Change Notice

Design Change for FR01A Stick Tube Packaging

Nihon Kaiheiki Ind. Co., Ltd.

Stick-Tube Dimensions and Quantities

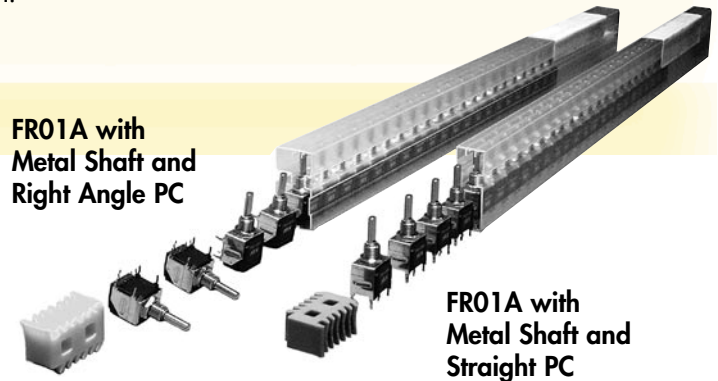
The stick-tube packaging has been redesigned for the FR01A with metal shaft, both the straight PC and the right angle PC. The dimensions have changed for the stick tubes, thereby changing the quantities contained.

The color of the stopper identifies termination types: green is used for the straight PC, and yellow for the right angle PC.

FROM		TO	
Straight PC Quantity: 50 		Straight PC Quantity: 25 	
Right Angle PC Quantity: 50 		Right Angle PC Quantity: 25

Series FR01 new stick-tube packaging will be effective on March 27, 2006.
